NOTICE TO CONTRACTORS BIDDING THIS PROJECT

Project Title: Building and Site Improvements at 6741 Downing Avenue, Bakersfield, CA

Contract No: 26016

ADDENDUM No. 5

DATE	ISSUED FOR
REVISION	DESCRIPTION
1	ADDENDUM #5
JOB	
DP	E311A
PM

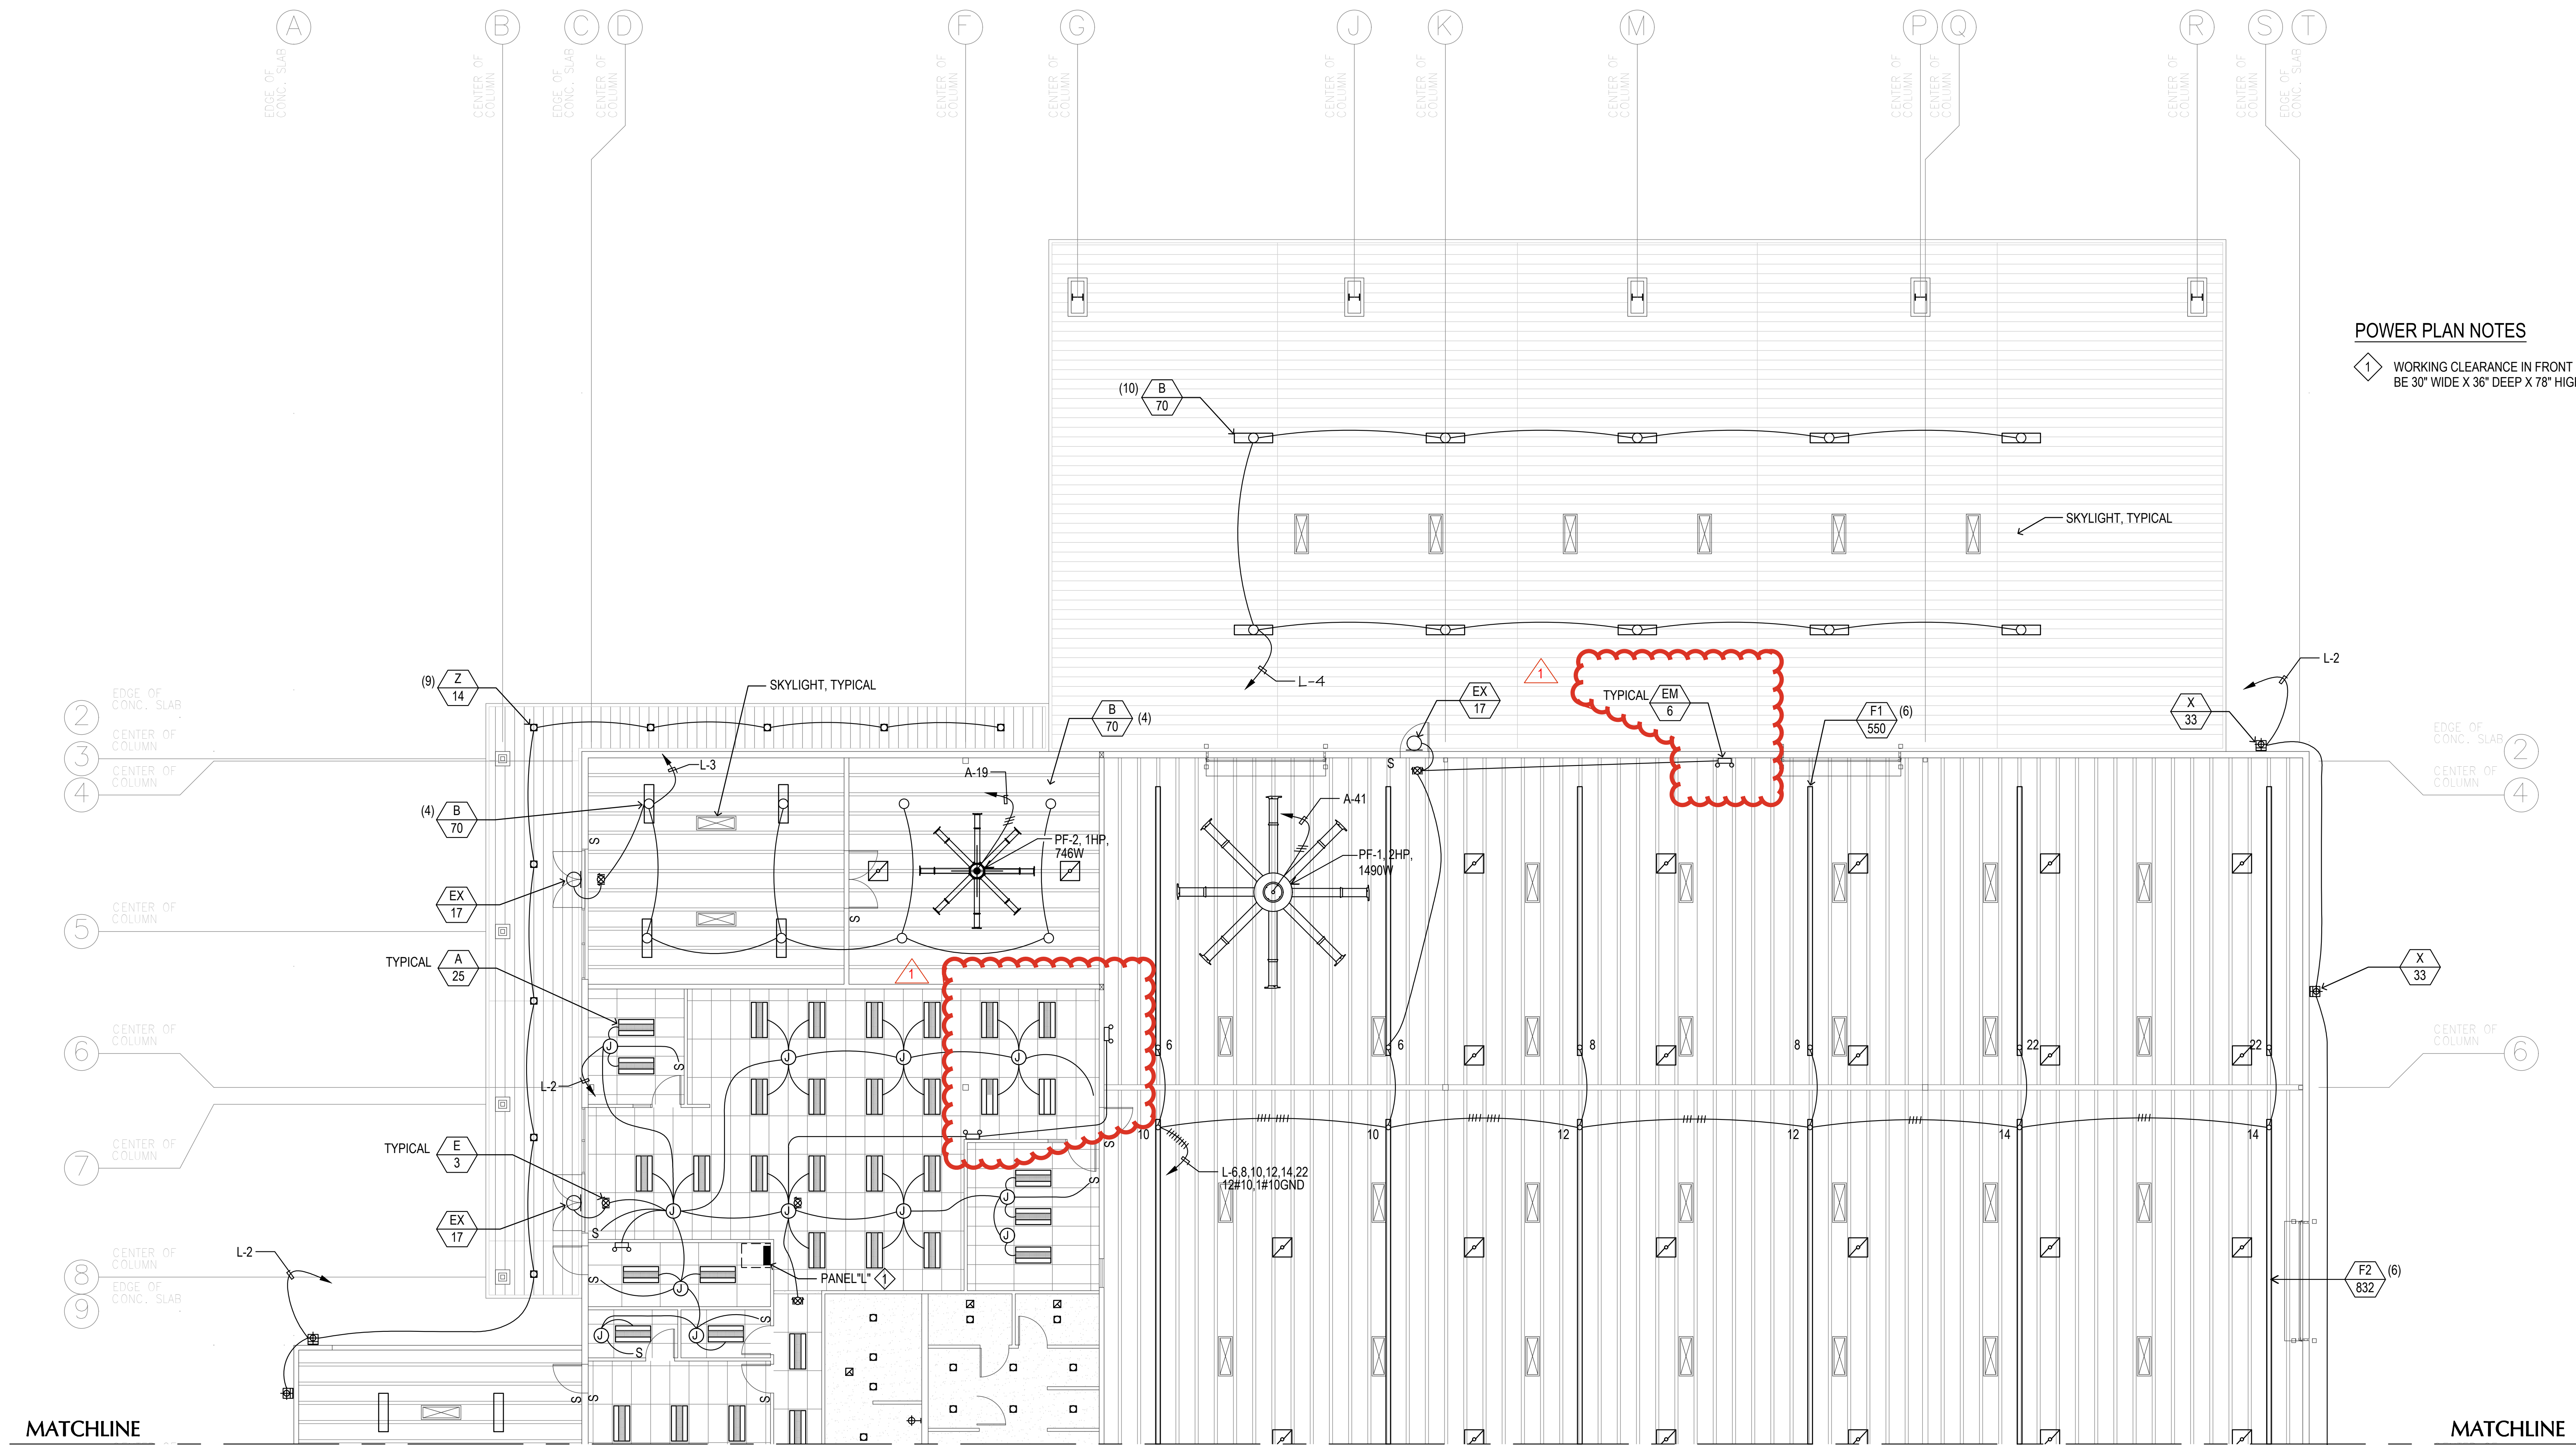
- u. Sheets E311 and E312 have been replaced with sheets E311A and E312A. Emergency light fixture tags have been added. The revised sheet is attached to this addendum.

LI.01A

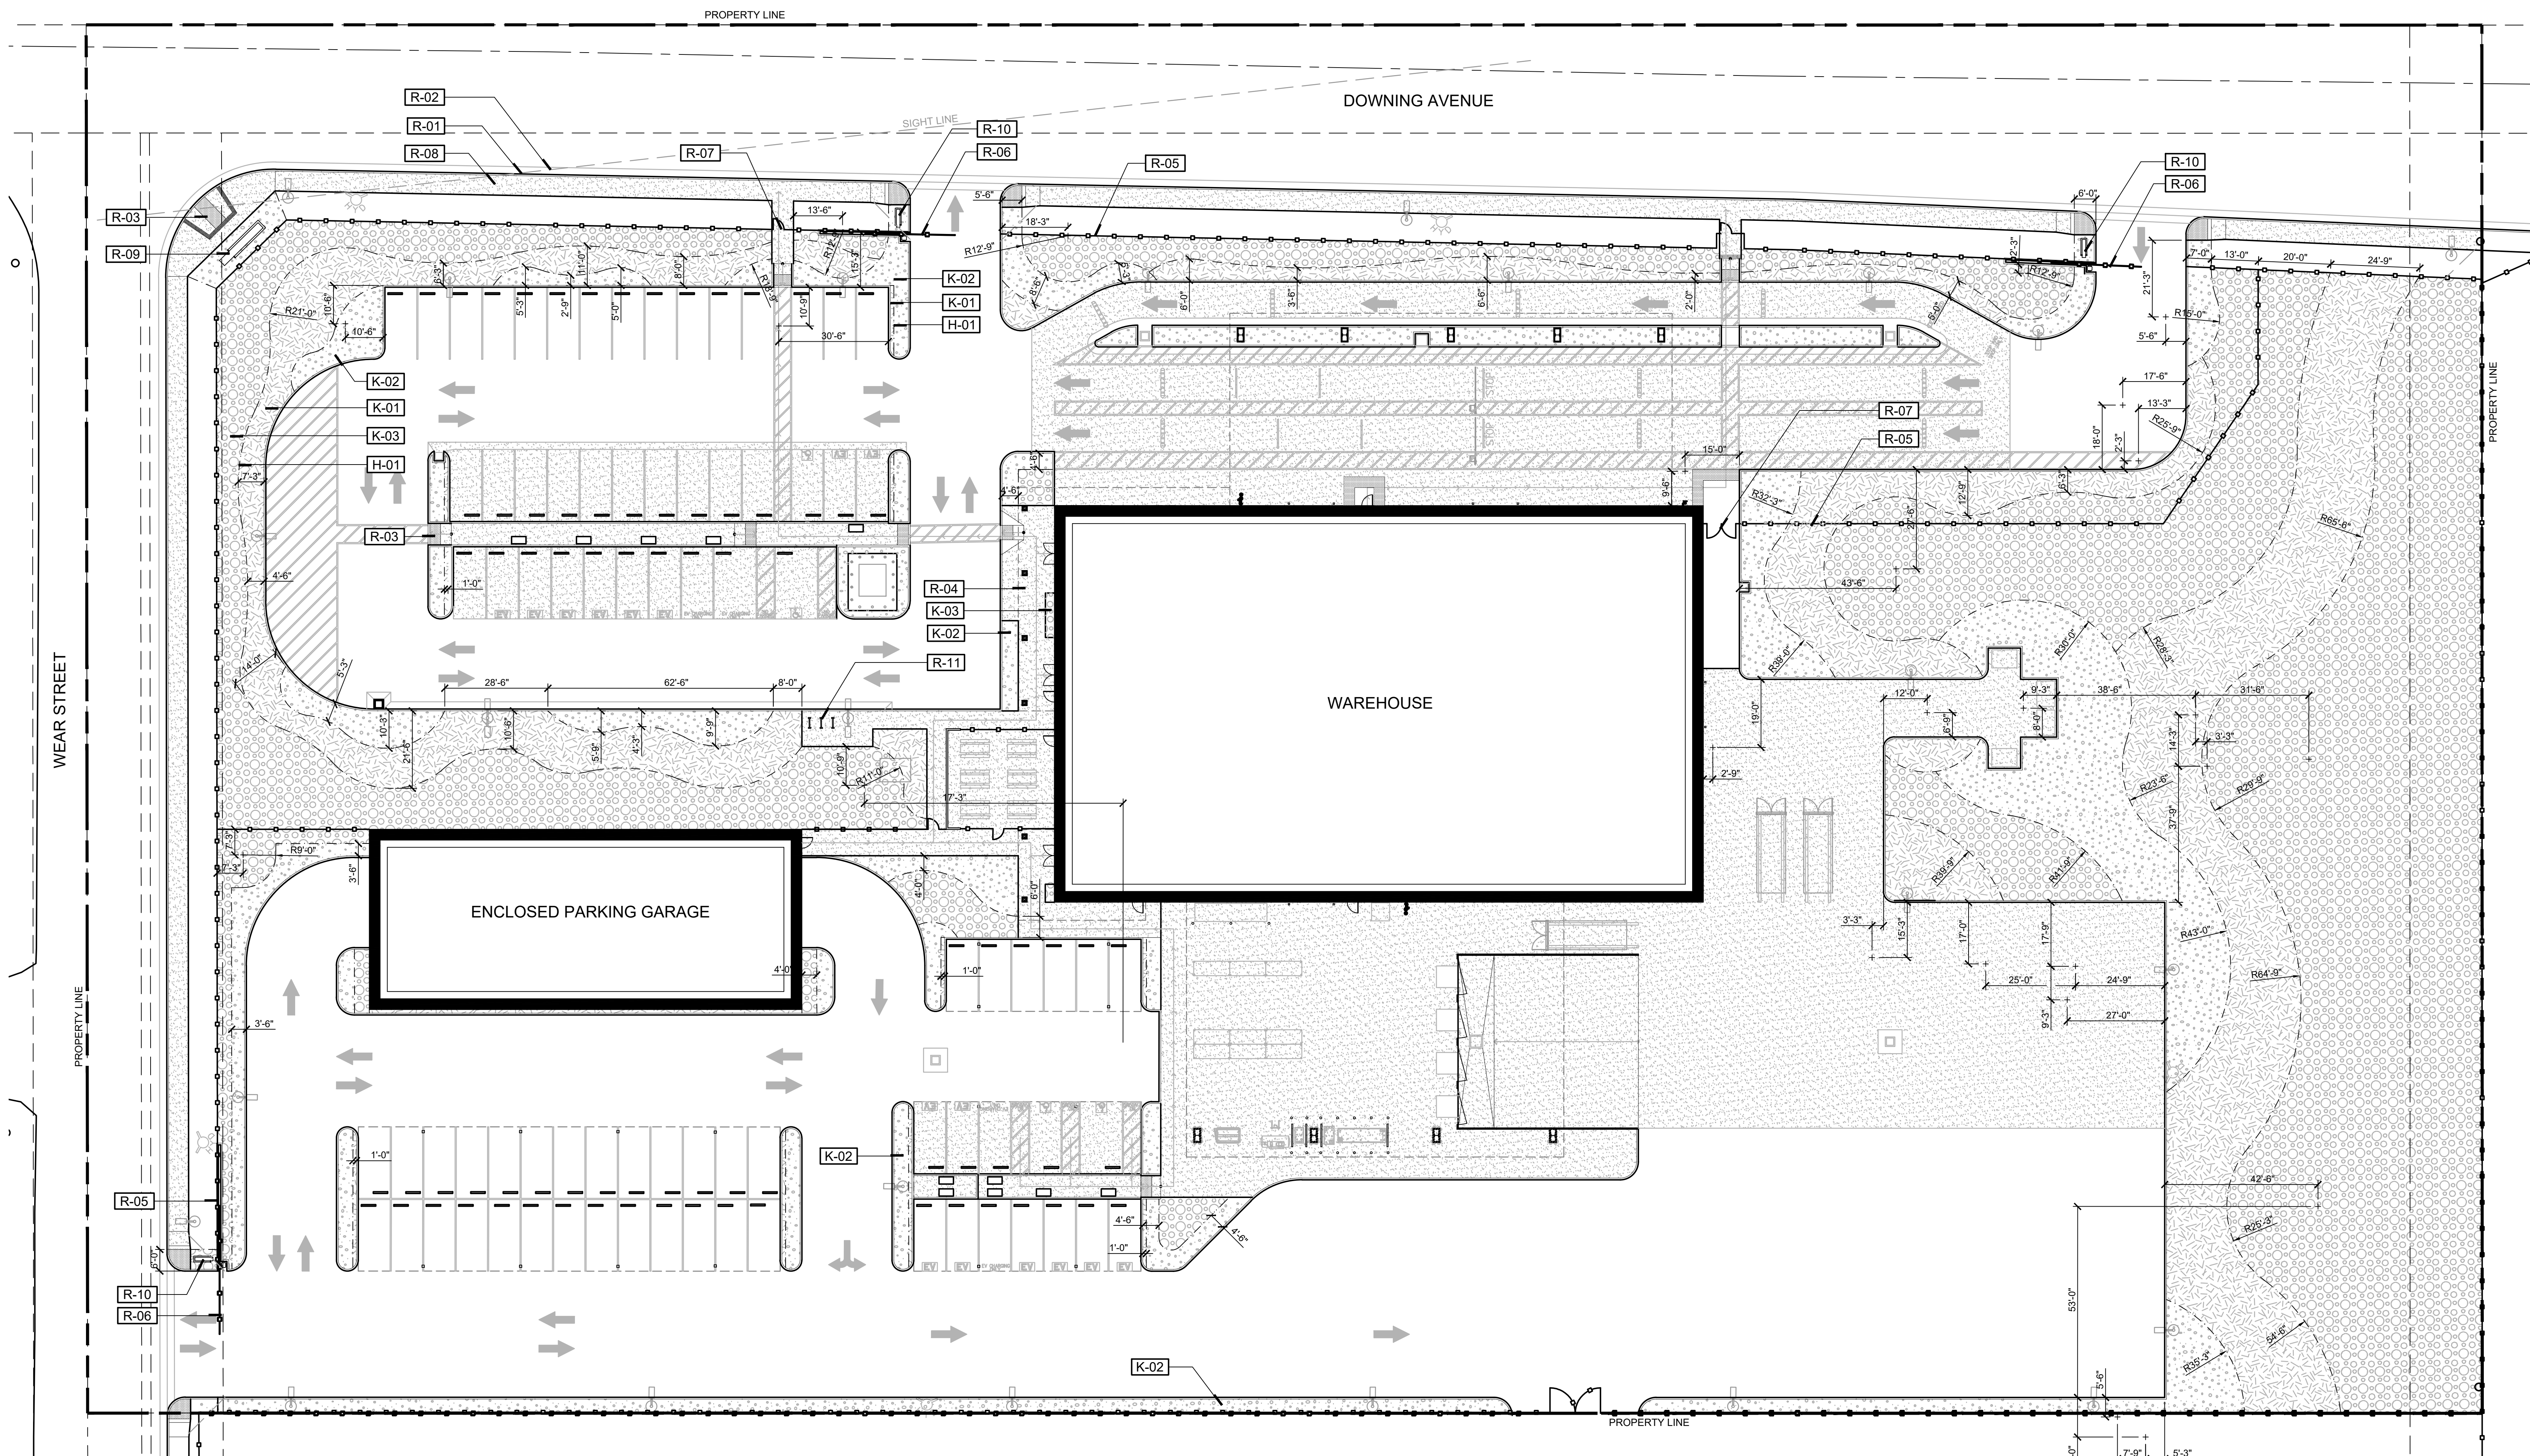
- x. Sheet LI.01 has been replaced with sheet LI.01A. Irrigation controller location has been clarified. Irrigation sleeving information has been updated. The revised sheet is attached to this addendum.

F GATE VALVE
1 1/2" = 1'-0" P-KE2-IRR-86

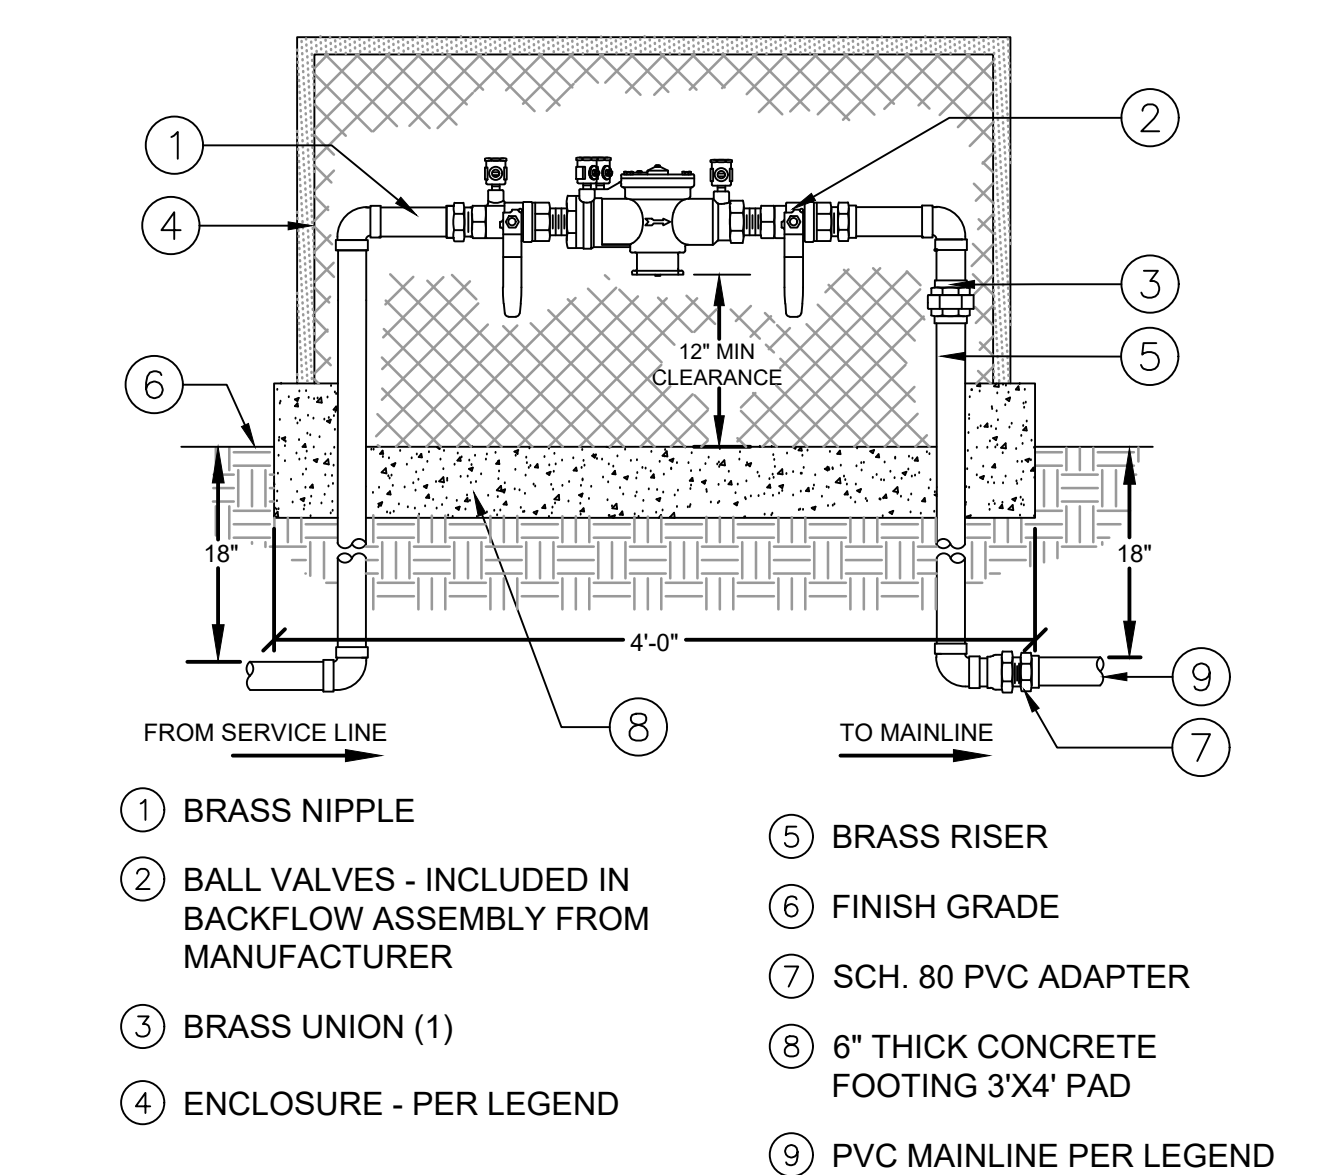
- y. Sheet LD.01 has been replaced with sheet LD.01A. Detail F/LD.01 has been updated. The revised sheet is attached to this addendum.
- z. Sheet LD.02 has been replaced with sheet LD.02A. Detail J/LD.02 has been updated. The revised sheet is attached to this addendum.
